Access Compliance Report

Public Rights-of-Way

Intersection ID: N/A	Main Street: DALLAS_BAY_RD	Cross Street: HAMILTON_BRIDGE_RD	Location: SE
ADA ID: 7F14962B06AB	Ramp Type: Perp	Initial Pass/Fail: Fail	Overall Compliance: No
			Severity Score: 21.25

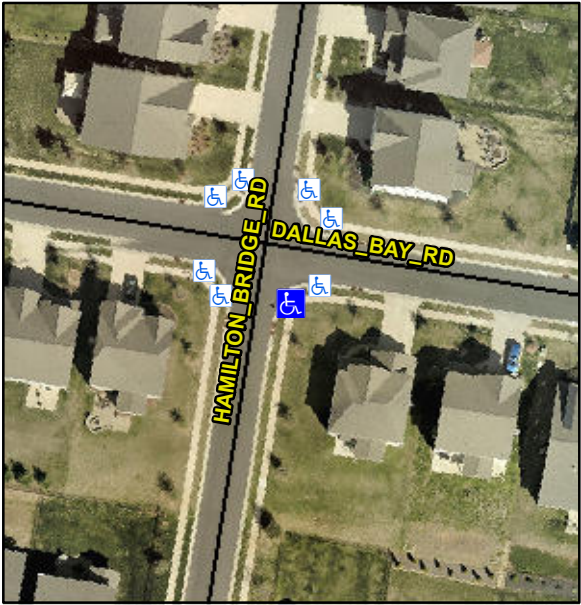
Codes/Mitigation Info/Possible Solution		Field Measurements/Component Compliance			
	<p>Possible Solutions:</p> <p>Remove & Replace Entire Ramp.</p>	<p>Surveyor Notes:</p> <p>N/A</p>	<p>PROW/ADA:</p> <p>Not Found, R304.5.1, R304.2.2</p>		
Street 1 Name	HAMILTON BRIDGE RD				
Stop Condition-Street 2	StopSign				
Street 2 Name	N/A				
Stop Condition-Street 1	N/A				
Total Cost:		\$	1850.00

Compliance	Description	Data	Compliance	Description	Data
N/A	Ramp Length (in)	45.0	No	Ramp Slope (%)	10.0
No	Ramp Width (in)	47.5	Yes	Ramp XSlope (%)	0.8
N/A	Flare Type LT	N/A	N/A	Flare Type RT	N/A
N/A	Flare Slope LT (%)	N/A	N/A	Flare Slope RT (%)	N/A
N/A	Flare Traversable LT?	N/A	N/A	Flare Traversable RT?	N/A
N/A	Landing Length (in)	N/A	N/A	DWS Provided?	N/A
N/A	Landing Width (in)	N/A	N/A	DWS Contrast?	N/A
N/A	Landing Slope (%)	N/A	N/A	DWS Length (in)	N/A
N/A	Landing X Slope (%)	N/A	N/A	DWS Full Width?	N/A
N/A	Landing Curb? (Y/N)	N/A	N/A	DWS Offset (in)	N/A
N/A	Shared Landing?	N/A			
N/A	Gutter Ponding?	N/A	N/A	Gutter Slope (%)	N/A
N/A	Gutter Lip Ht (in)	1.0	N/A	Gutter X Slope (%)	N/A
N/A	Painted X Walk1?	No	N/A	Painted X Walk2?	N/A
	X Walk 1 Direction	To W		X Walk 2 Direction	N/A
N/A	X Walk 1 Width (in)	N/A	N/A	X Walk 2 Width (in)	N/A
	X Walk 1 Slope (%)	4.1		X Walk 2 Slope (%)	N/A
	X Walk 1 X Slope (%)	1.6		X Walk 2 X Slope (%)	N/A
